REMARKS

Serial No.: 10/082,141

ANNOTATED SHEET SHOWING CHANGES  
SERIAL NO. 10/082,141  
CONFIRMATION NO. 5402  
Satoru INOUE et al.

**FIG. 4** PRIOR ART

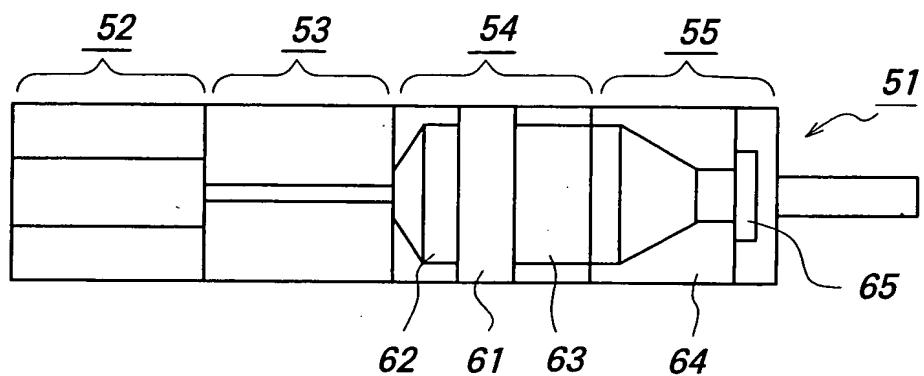
1. Objections were stated to the drawings. Submitted herewith are copies of Figures 3 and 4 revised to include the Prior Art legend. Withdrawal of the objection to the drawings is respectfully requested.

Attachments: 1 annotated sheet showing changes Figs. 4 and 5  
1 replacement sheet Figs. 4 and 5
